Technical product information

Topic	Bentayga V8 Kovomo - DTC P227900 evident within the engine control unit 0001
Market area	United States E05 Bentley USA and rest America (6E05)
Brand	Bentley
Transaction No.	2071575/3
Level	EH
Status	Approval
Release date

Figure 1

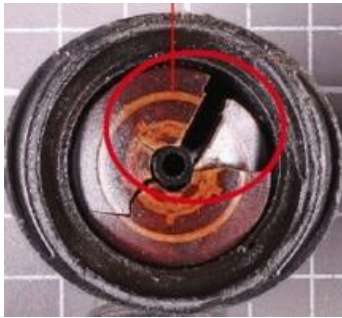
The issue described is due to a split breather diaphragm in one or both of the turbocharger full load pipes (Figure 1)

The diaphragm of the bank 1 turbocharger full load pipe is located at the end of the pipe and can be easily located however the diaphragm of the bank 2 turbocharger full load pipe is installed within the pipe and therefore will not be visible

Hint: The diaphragm of the A,B and E suffix parts is orange (Figure 1)

Figure 2

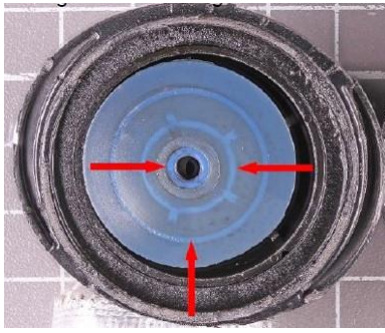
Hint: The diaphragm of 0P2 103 210G and 0P2 103 211H are blue (Figure 2)

Figure 4

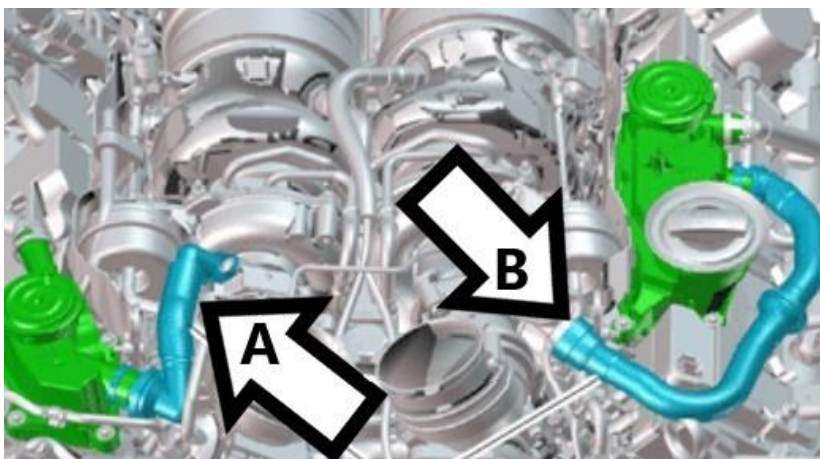
Referring to Figure 4

- Point A - Is the bank 1 (right) turbocharger full load pipe
- Point B - Is the bank 2 (left) turbocharger full load pipe

1) Referring to Rep.Gr 21 - Replace the bank 1 (right) and bank 2 (left) turbocharger full load pipes

Figure 5

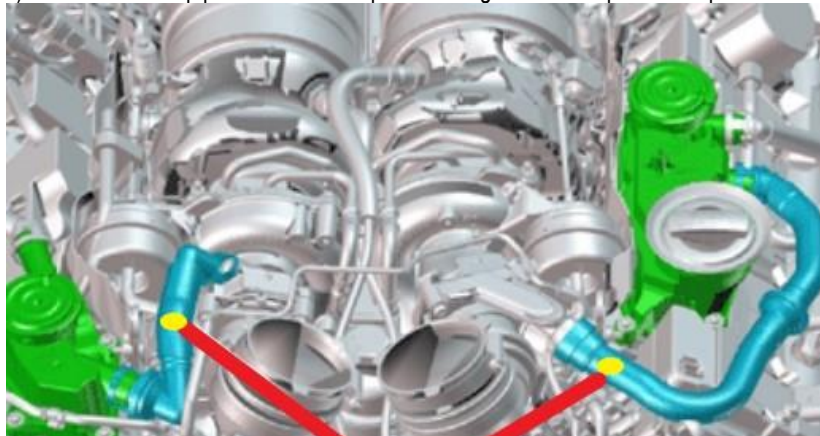
2) To confirm both pipes have been replaced using the H level parts the operative must place a yellow paint mark as shown in Figure 5
